## SUPPLEMENT NO. 1

### SAFETY ANALYSIS REPORT T-2 Shipping Package

This supplement to the April 1980 Safety Analysis Report (SARP) for the T-2 Shipping Package covers the addition of a stainless steel, sheet-metal liner inside the shipping case. The sheet-metal liner serves to protect the "Marinite" insulation from physical damage and contamination during normal loading and unloading operations.

FIGURE 1.2 T2 SHIPPING CASE COMPONENTS

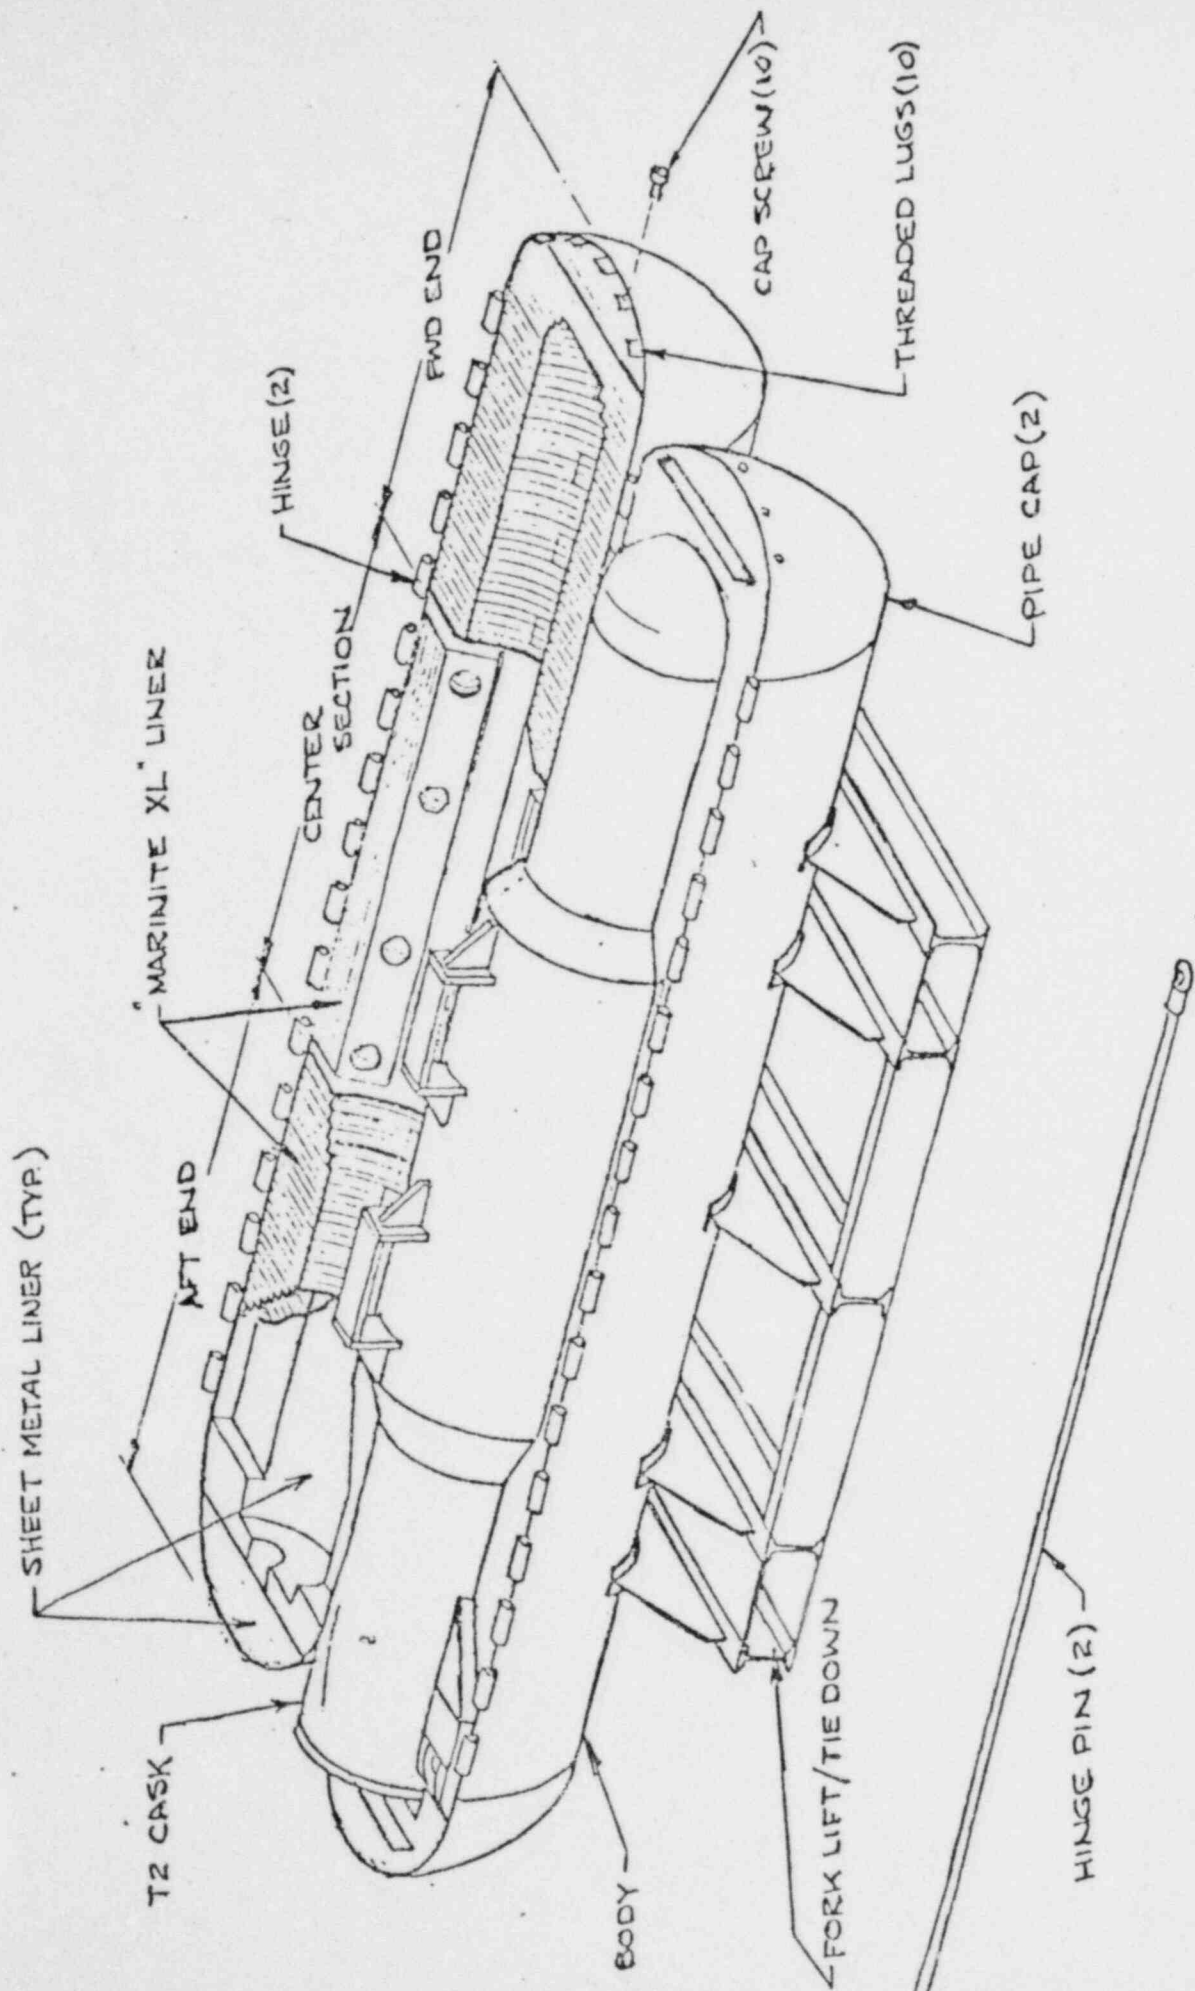
A 16-gauge (0.0625-in. thick) stainless steel, sheet-metal liner inside the shipping case protects the "Marinite" from physical damage and possible contamination during normal loading and unloading operations. A 1/8-in. clearance is maintained between the sheet-metal liner and the cask, except at the cone-shaped end plates. Fig. 1.2 shows the principal elements of the T-2 shipping case.

There is a minimum clearance of 1/8-in. between the sheet-metal liner of the shipping case and the cask at each end of the cart, which is sufficient to accommodate the 1/4-in. longitudinal elongation of the cask.
